REPORT TO THE CALGARY PLANNING COMMISSION

DEVELOPMENT PERMIT	ITEM NO: 02	
	CPC DATE:	2011 April 28
	DP NO:	DP2010-4161

PROPOSAL:
New: Multi-Residential Development (168 units)

APPLICANT: BKDI Architects	OWNER: Qualex-Landmark Advance inc.
MUNICIPAL ADDRESS: 626 - 14 Avenue SW	LEGAL DESCRIPTION: Plan A1, Block 90, Lots 27 to 34 (Map 16C)
EXISTING LAND USE DISTRICT(S): CC-MH Centre City Multi-Residential High Rise	
AREA OF SITE: 0.242 ha ± (0.597 ac ±)	
CURRENT DEVELOPMENT: Vacant

Landscape Context Plan

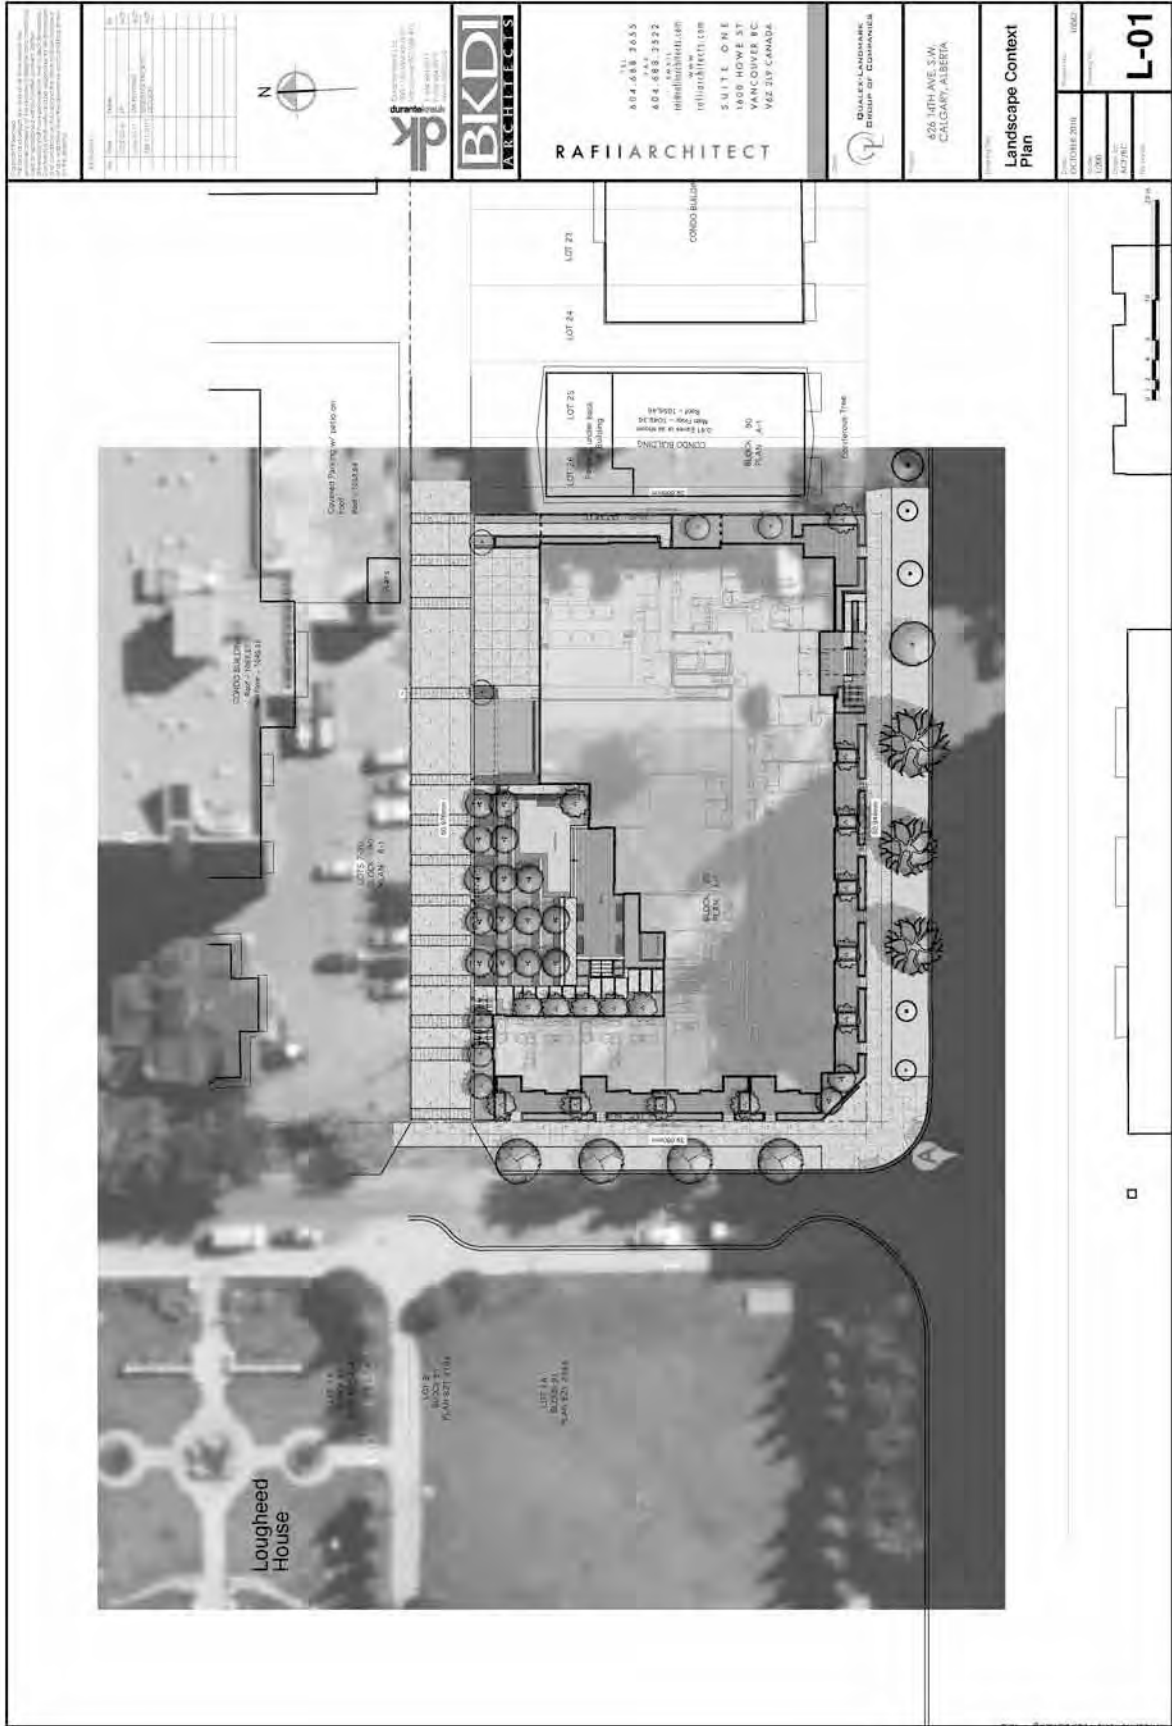
8. Indicate new service connections on site and landscape plans. Keep new service connections away from the 28 metre boulevard area near the three public spruce trees. If this is not possible, Urban Forestry requires compensation for any public trees removed to facilitate new services.

EAST ELEVATION

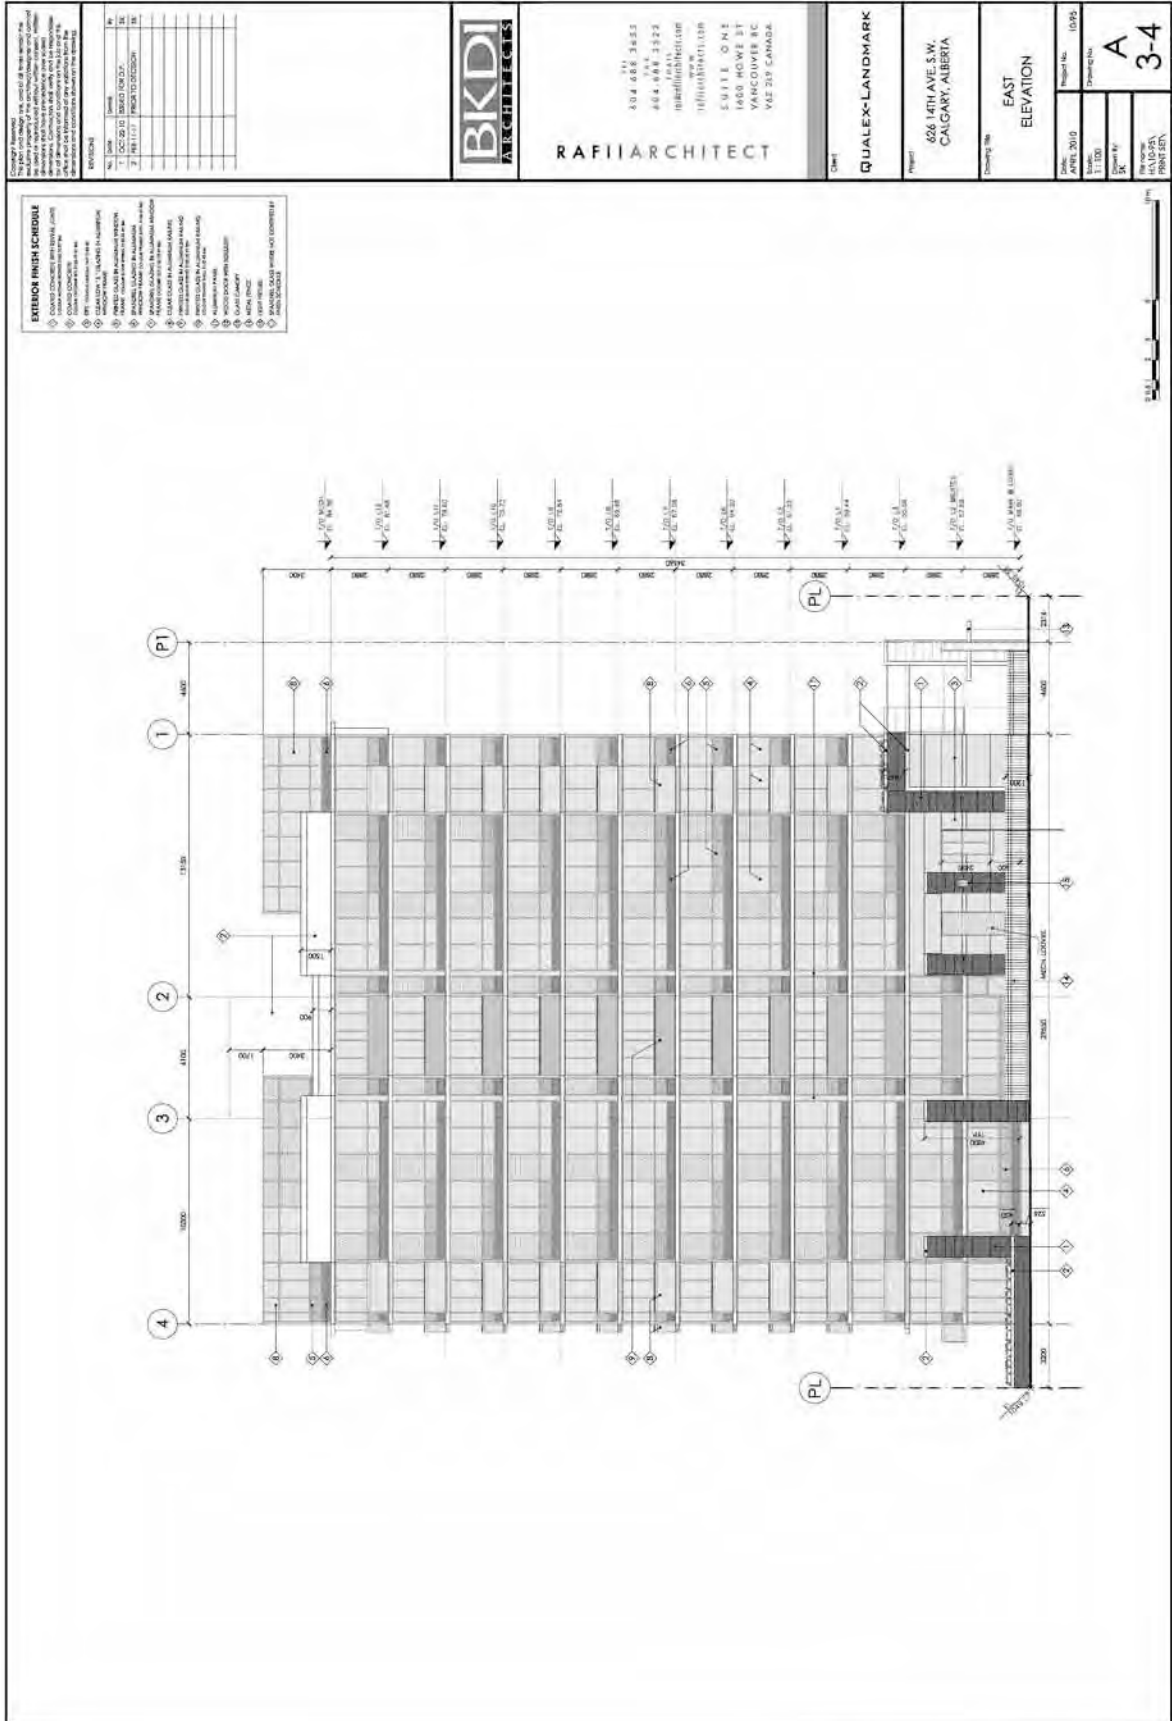
- The Panel feels that the elevator shaft enclosure can be more successfully integrated into the principal building mass. The proposed extension of the glazed façade does not adequately achieve this objective.
